Recycling & Recovery

RE: SSD 15_7267 Wetherill Park Transfer Station Capacity Increase – Proposed Modification

Attachment A: Revised site plan and staging plan

STAGING PLAN

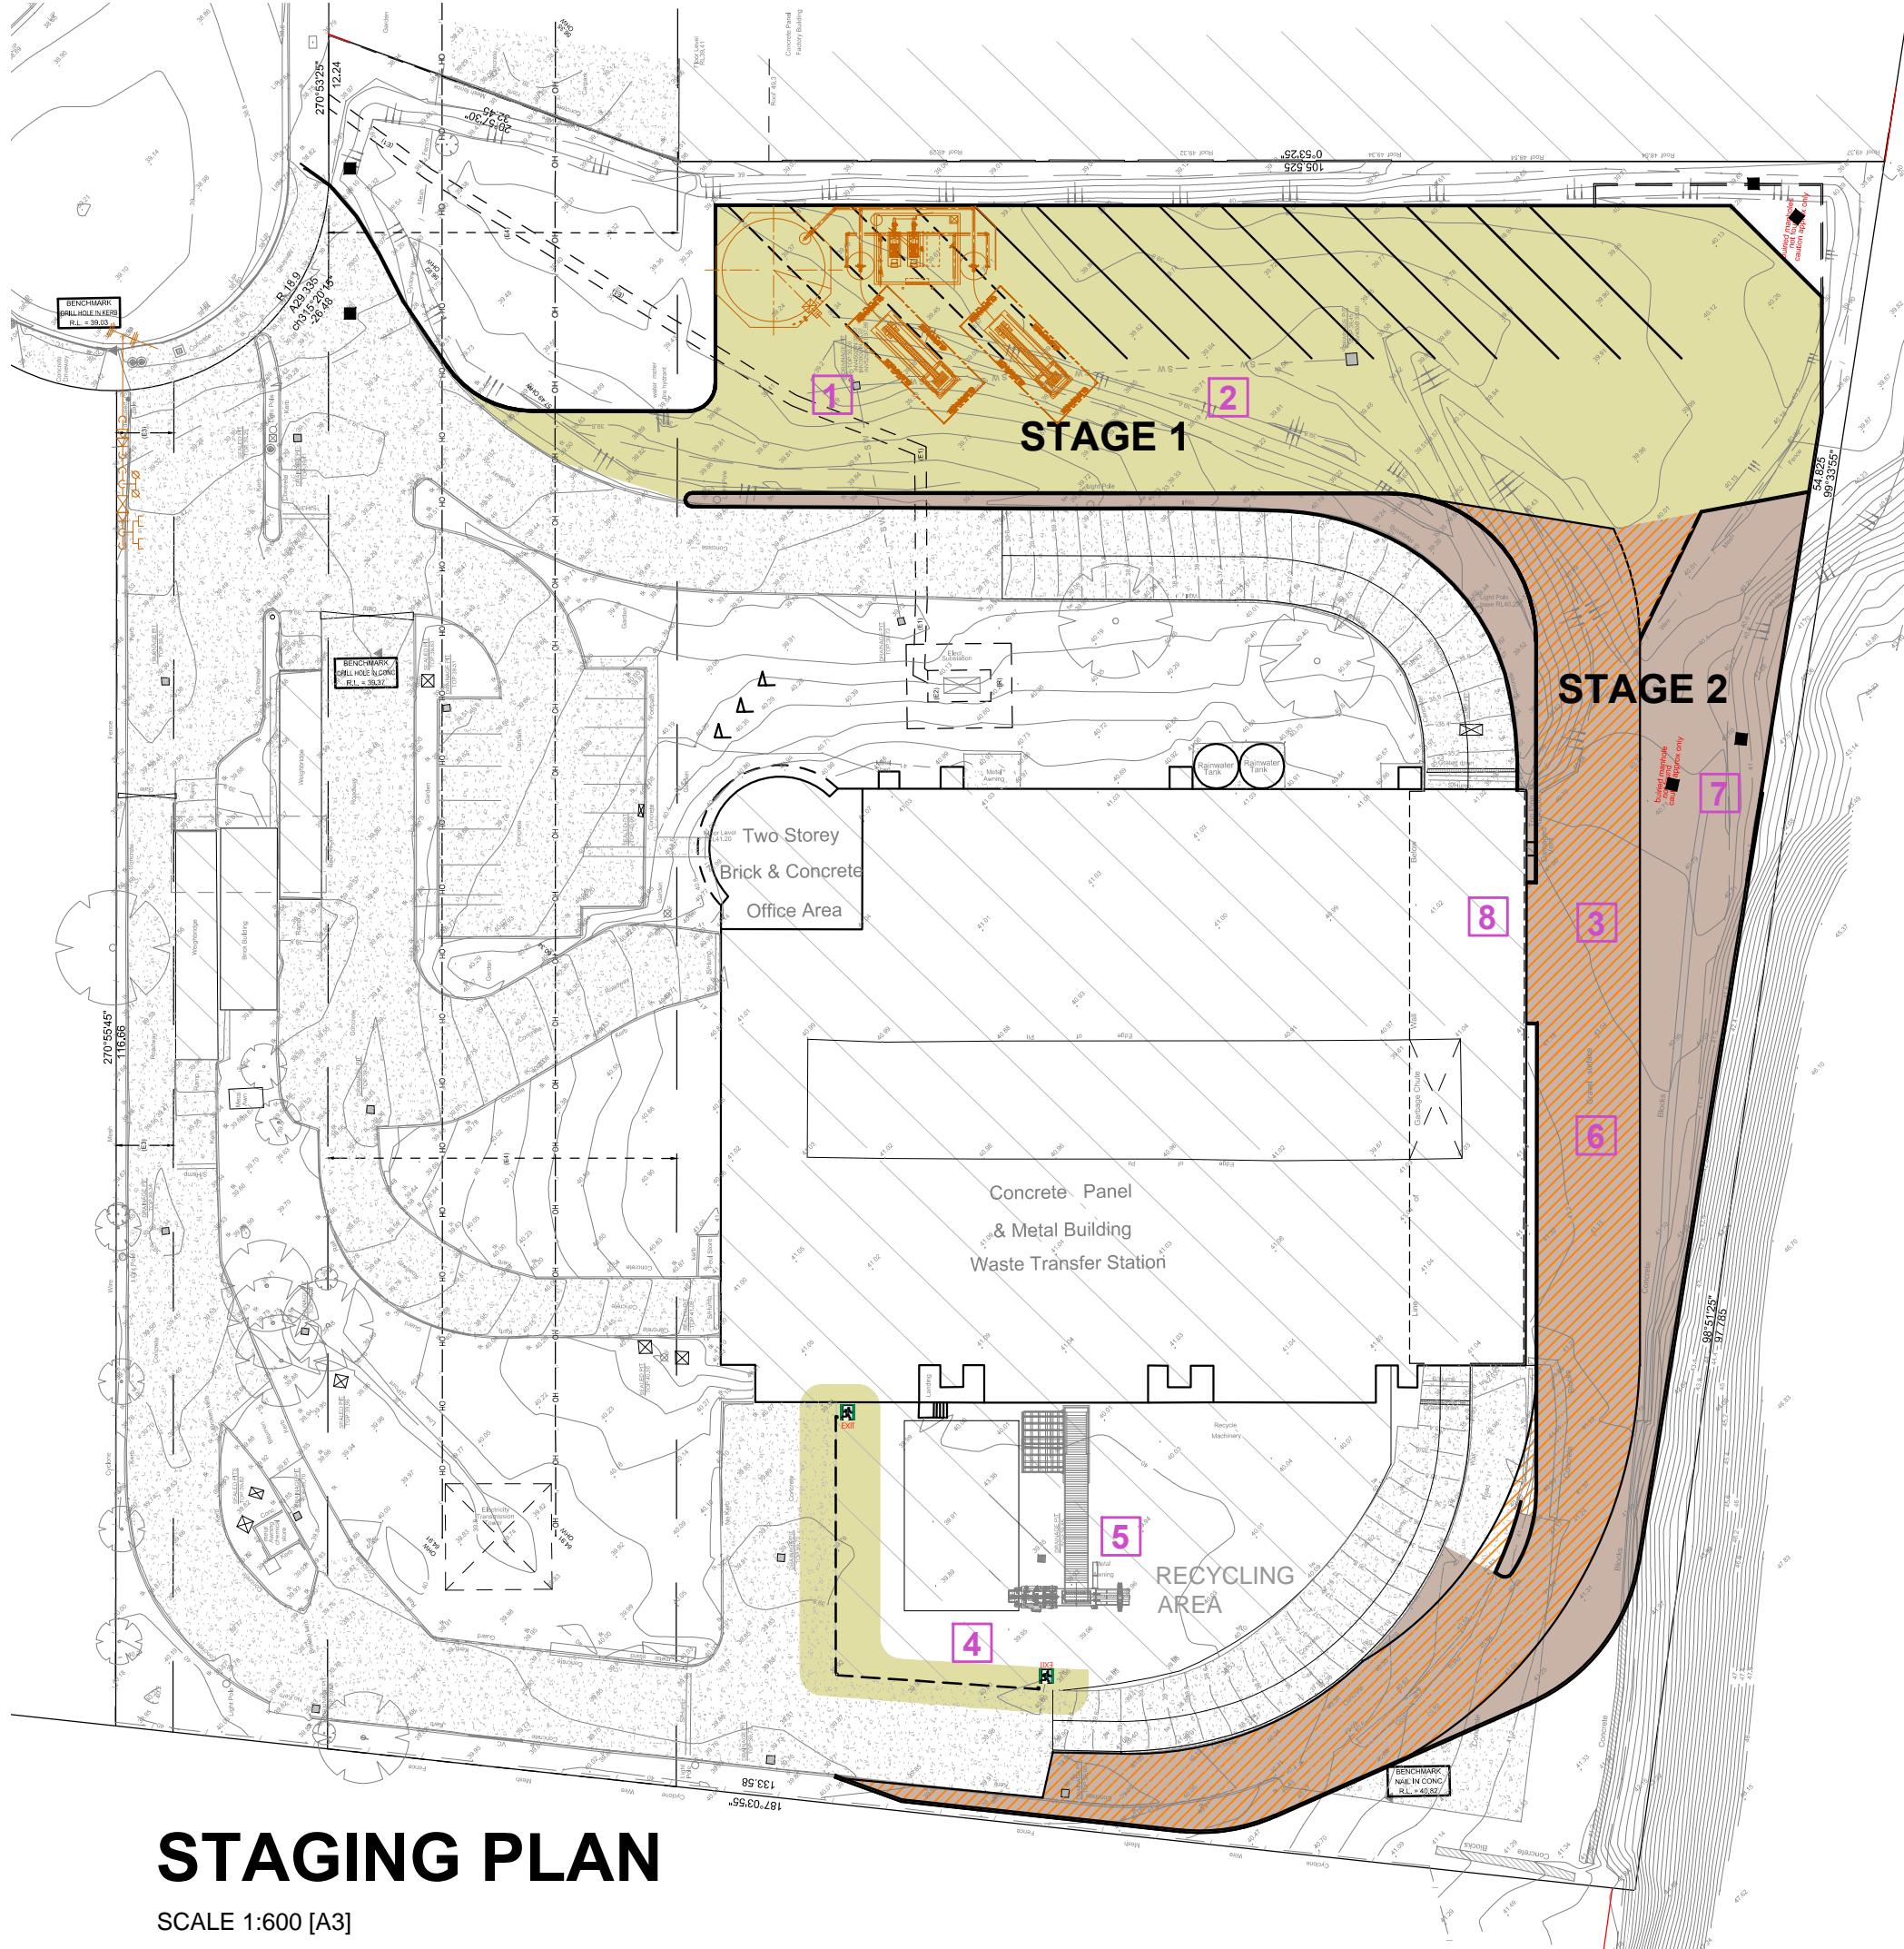
A27 (a) Prior to the commencement of Stage 1 Expanded Operations, the Applicant must ensure a Final Occupation Certificate or a Compliance Certificate has been issued for Stage 1 Works per submitted *Staging Plan - Sheet Number CC01* prepared by Envision Group dated 28 August 2018.

- Fire services upgrade
- Construction of “Stage 1” permanent paving & line marking of truck parking
- Temporary perimeter access road
- Proposed retractable, fire compliant litter prevention curtain
- Plant and equipment per drawing layout

(b) Prior to the commencement of Stage 2 Expanded Operations, the Applicant must ensure a Final Occupation Certificate or a Compliance Certificate has been issued for Stage 2 Works per drawing *Staging Plan - Sheet Number CC01* prepared by Envision Group dated 28 August 2018.

- Construction of “Stage 2” permanent paving, and line marking of truck parking
- Removal of concrete panel and construct new roller shutter door at the rear of transfer station

PROPOSED TRUCK PARKING SPACES TO BE REMOVED DUE TO REQUIRED FIRE SERVICES

PROPOSED INDUSTRIAL SHED AS APPROVED UNDER DA SSD7267 - TO BE DELETED AS PART OF PROPOSED MODIFICATION APPLICATION

SITE PLAN

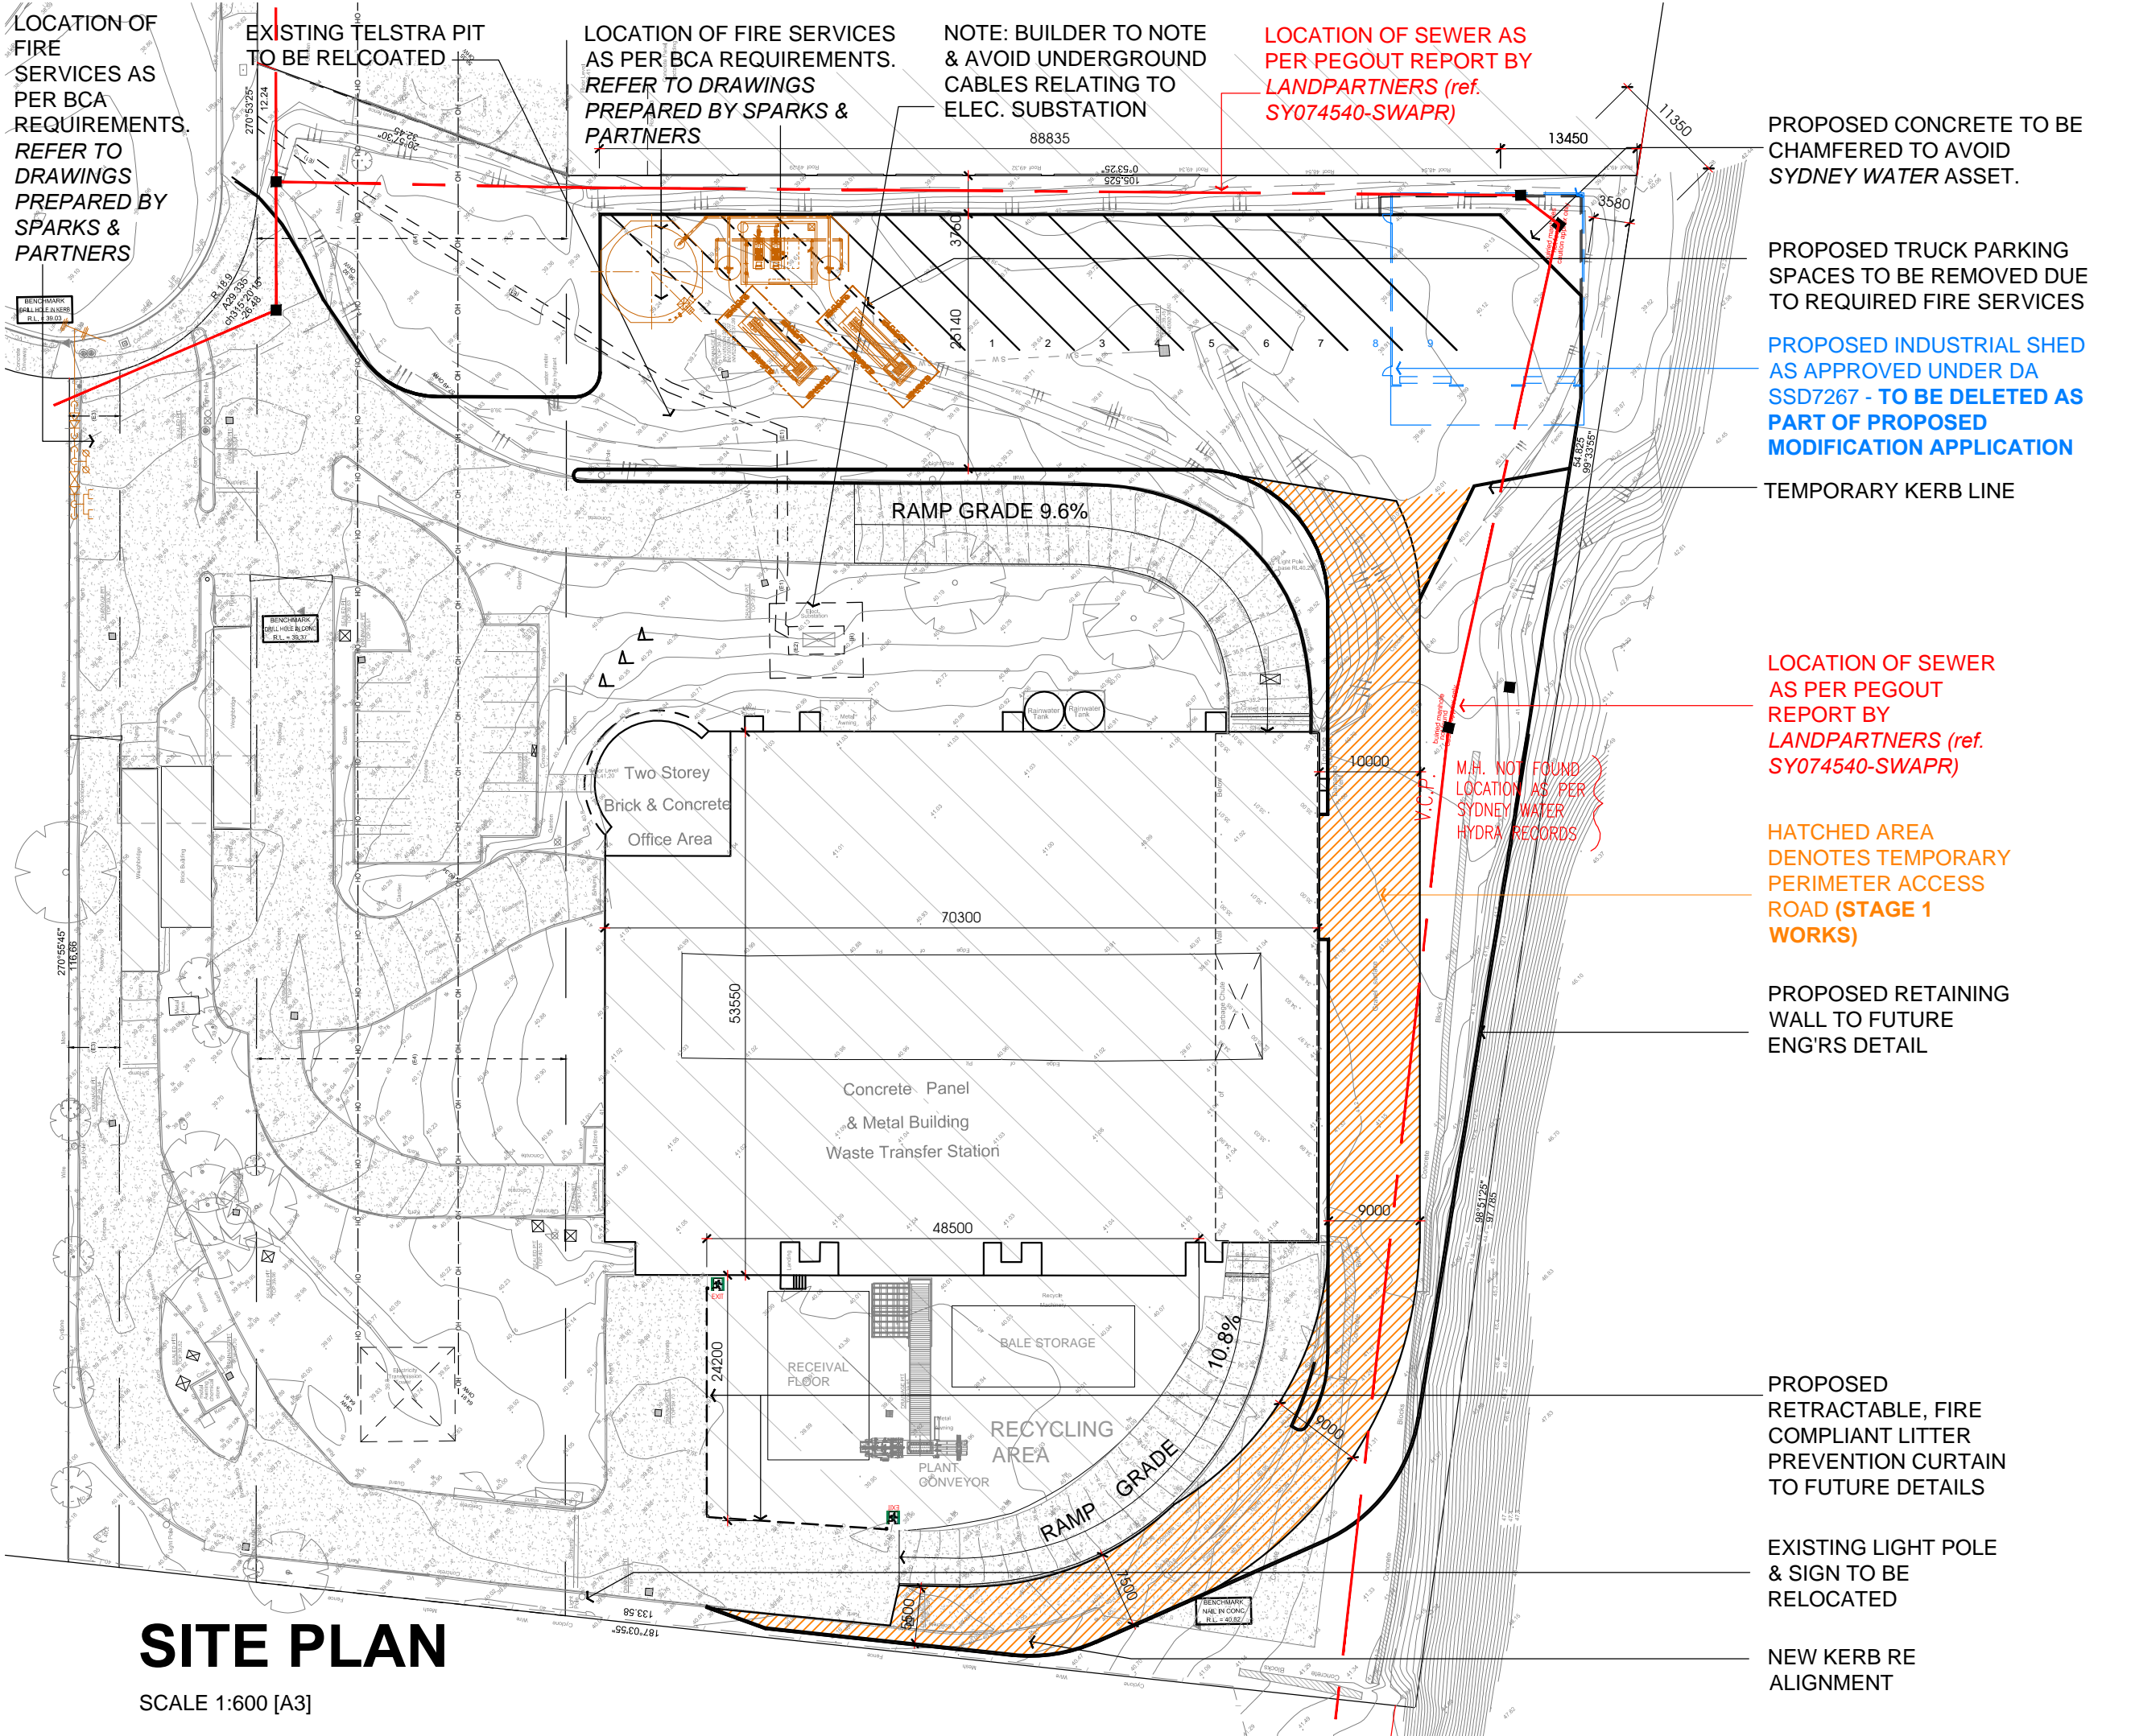
HATCHED AREA DENOTES TEMPORARY PERIMETER ACCESS ROAD (STAGE 1 WORKS)

PROPOSED RETAINING WALL TO FUTURE ENG'RS DETAIL

PROPOSED RETRACTABLE, FIRE COMPLIANT LITTER PREVENTION CURTAIN TO FUTURE DETAILS
